EXHIBIT #4c

Re: **Phillips 66 Company Propane Recovery Project, November 2013 Proposed Final Environmental Impact Report, SCH #2012072046; County File #LP12-2073**

Expert Report of Greg Karras
Communities for a Better Environment (CBE)
4 September 2013

Phillips 66 Company Propane Recovery Project
Draft Environmental Impact Report released in June 2013 by the
Contra Costa County Department of Conservation and Development
State Clearinghouse #2012072046
County File #LP12-2073

Chart 2. Sulfur and imports content of West Coast refinery crude feeds, 1985–2012
PADD 5 data from the U.S. Energy Information Administration (www.eia.gov/petroleum/data.cfm).

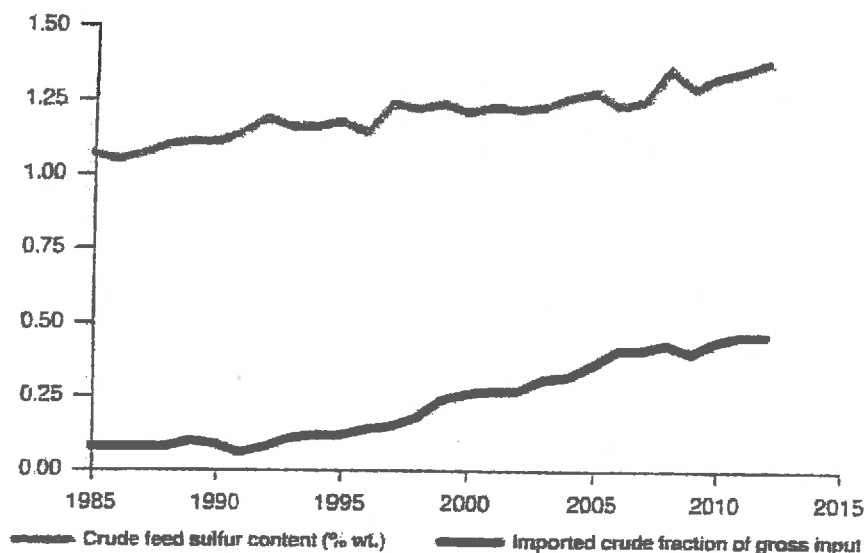
19. This new, dense crude slate likely will include more oil derived from “tar sands” bitumen. The project would commit the refinery to coker feed-rich crude over a period when the worldwide portion of high-density crude supplied by “heavy oil” and bitumen is likely to grow dramatically.²⁸ Bitumen has already come to dominate crude production in Canada,²⁹ the largest source of U.S. crude imports.³⁰ Moreover, crude can account for up to 90% of a refinery’s operating costs,³¹ and tar sands bitumen is price-discounted (due in part to delivery constraints),³² so Phillips 66 is incented to run it, especially since the company’s affiliates produce two of the bitumen blends shown in Table 3.³³ Indeed, recent major projects expanded the Rodeo facility’s capacity to run more of these oils.³⁴ It now has vacuum distillation capacity to process a crude slate with atmospheric residua yield as high as 73% of the barrel, and coking capacity to process a slate with vacuum residua yield as high as 39% of the barrel,³⁵ which is more than enough to run the bitumen blends shown in Table 3.

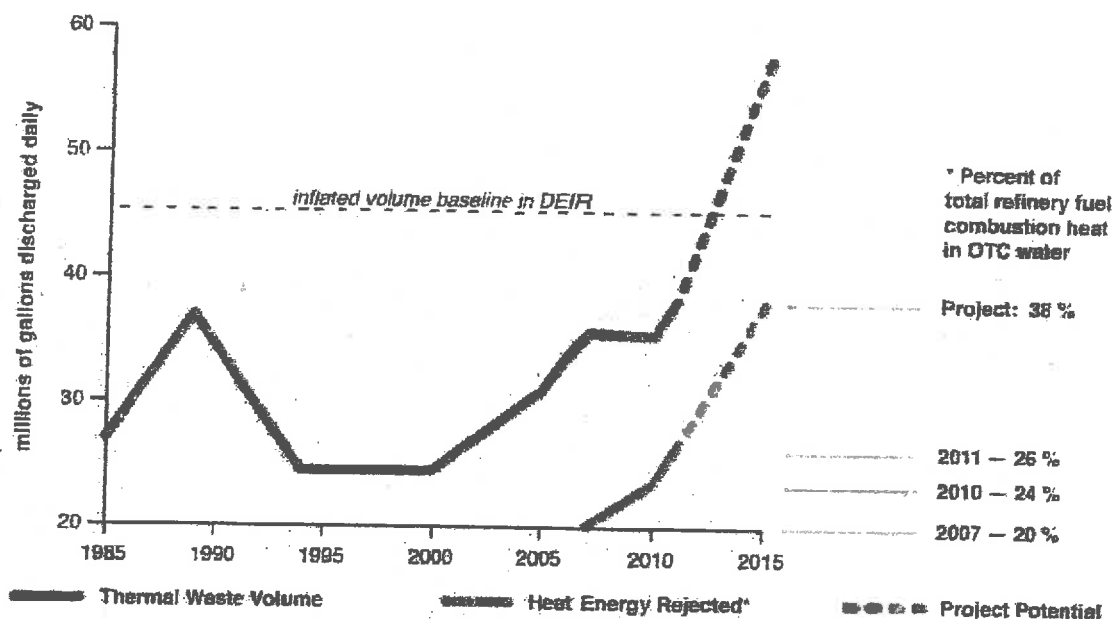
28. According to the DEIR, the OTC expansion to 57.6 million gallons/day (MGD) represents an increase of 12.2 MGD from a project baseline OTC flow of 45.4 MGD.⁴⁵ The DEIR asserts this 45.4 MGD baseline without any supporting documentation, but NPDES findings omitted from it show that average OTC flow never approached 45.4 MGD since at least 1985. See Chart 3. Further, the refinery was required to estimate impacts of related prior modifications on its OTC flow and estimated they would increase it to only ≈ 35.4 MGD.⁴⁶ Permit review analysis of post-modification continuous monitoring data to check on that estimate found OTC flow of ≈ 35.5 MGD in 2010, and by mid-2011 this monitoring showed a long-term average OTC flow of ≈ 38.3 MGD.⁴⁶ This evidence shows that the 45.4 MGD DEIR estimate inflates the project’s OTC baseline. Based on the proposed OTC expansion to 40,000 gpm (57.6 MGD) and the most recent NPDES long-term average OTC flow (38.3 MGD), the project could use ≈ 19.3 MGD of Bay water. This more accurate OTC flow increment (19.3 MGD) exceeds the increment the DEIR calculated from its inflated baseline (12.2 MGD) substantially.

29. Total heat rejected by OTC would grow, from ≈ 6.3 – 6.8 million gigajoules/year during 2007–2011 to ≈ 10.2 MM GJ/yr as a result of the project.⁴⁷ Waste heat rejected by the project flow increment (≈ 3.4 – 3.9 MM GJ/yr) would greatly exceed the total energy of additional fuel the DEIR states the refinery could burn for the project (1.23 MM GJ/yr).⁴⁸ Consequently, refinery wide reliance on OTC to reject waste heat would grow, from ≈ 20 – 26% of all fuel energy burned in the facility during 2007–2011, to $\approx 38\%$ of post-project refinery energy use.⁴⁹ See Chart 3. The DEIR does not identify or explain the discrepancy between the fuel it says the project would burn and the heat its expanded OTC could carry, and it does not disclose this increased refinery wide reliance on OTC.

Chart 5. Richmond refinery feedstock quality / 4-Sidecut pipe corrosion, 1989–2012.
From testimony presented in the 19 April 2-13 U.S. Chemical Safety Board public hearing at Richmond, CA.

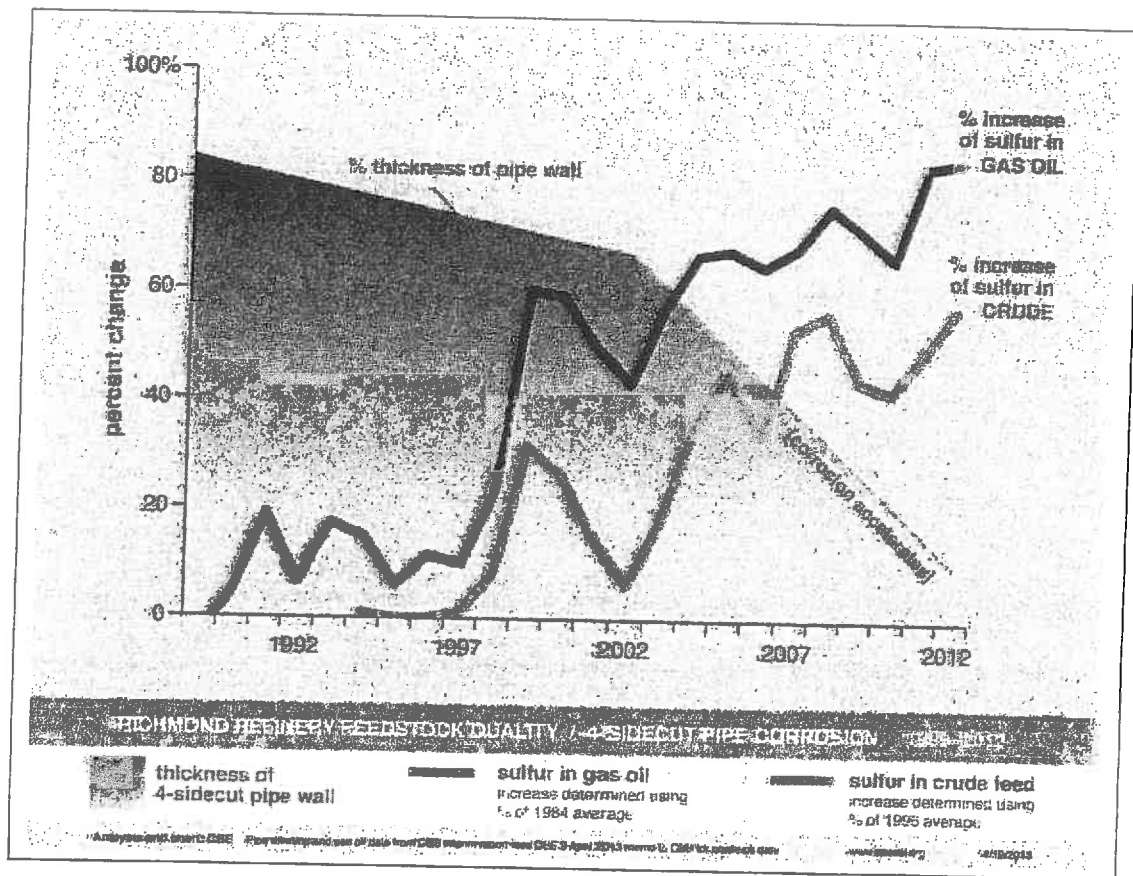
59. Switching to higher sulfur crude was a causal factor in the disastrous Richmond refinery fire on 6 August 2012. See Chart 4. Sulfur corrosion of the pipe section that ruptured catastrophically in the incident (gray shading), sulfur in the gas oil running through this pipe (black line), and sulfur in the refinery crude feed supplying that gas oil (red line) are shown in this chart. The percent change from baselines is shown.¹⁰¹ As sulfur increased in the crude, it increased in the gas oil distilled from that crude and running through the pipe, and sulfidic corrosion began to thin the wall of this pipe more than four times faster than before that dramatic sulfur increase. See Chart 4. This example of an ultimately disastrous feedstock substitution hazard applies to the SFR and the even more inherently hazardous crude feed that likely would result from the project.

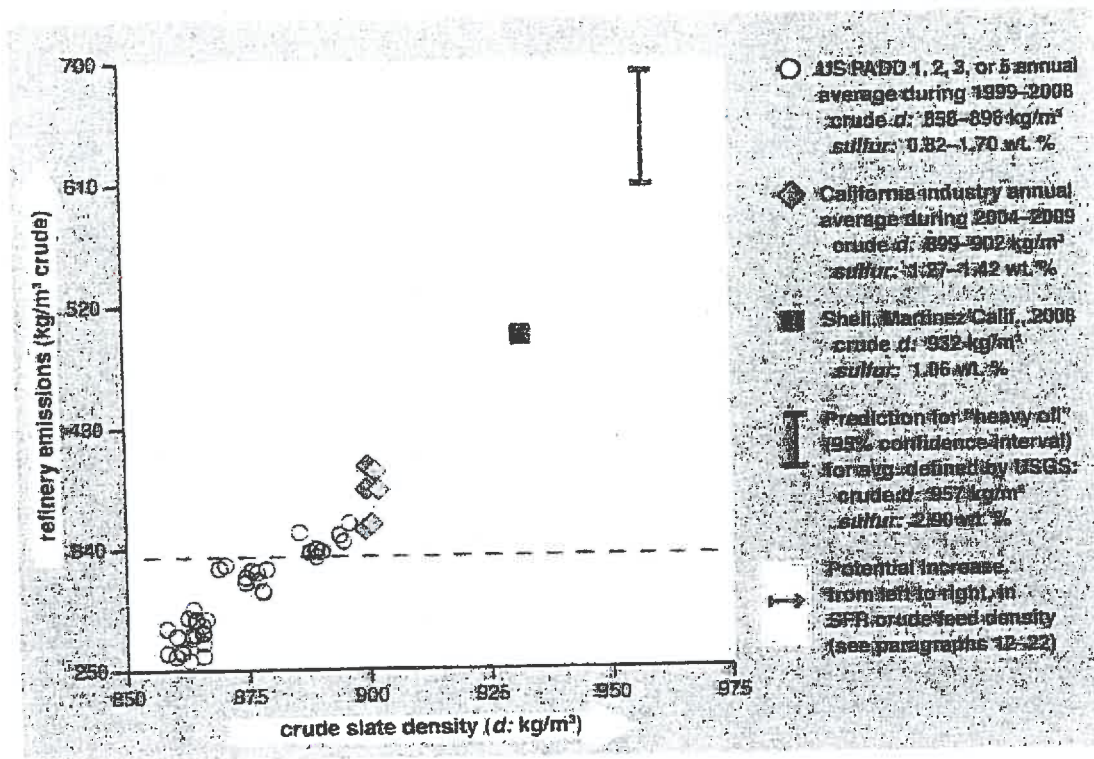
slate density from 915–952 kg/m³ and sulfur from 1.5–3.4% could increase the average refinery's energy intensity by ≈2.75 GJ/m³ crude refined.¹¹⁷ Assuming the refinery fuels reported in the DEIR,¹¹⁸ and this average energy increment, SFR emissions of CO₂ would increase by ≈135 kg/m³, or ≈940,000 tonnes/year. (Each 90 kg/m³ increment on the vertical scale in Chart 5 represents emission of 627,000 tonnes/yr at SFR's 120,000 b/d capacity.) This ≈940,000 tonnes/yr value indicates the scale of potential impact rather than its precise quantification, as discussed directly below.
